October 28, 2025

ADDENDUM III

PURCHASE OF CONSTRUCTION SERVICES FOR SUNDANCE RENOVATION AT NORTHEAST LAKEVIEW COLLEGE **RFP 2026-0080**

XIII. **QUESTION:** Section: 09 81 00 Material: Sprayed Cellulose Fiber Acoustical Insulation Color: Black Thickness: 1 1/2 in

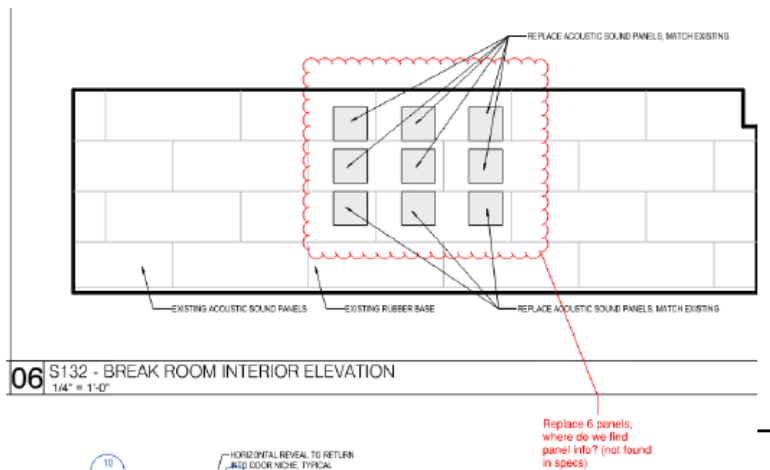
I cannot seem to locate within the plans, where the k-13 is to be sprayed. I am looking for a little clarity so that we may put in a proposal.

ANSWER: Spray insulation to be applied at E113 Commercial Electrical Lab and E120 Residential Electrical Lab.
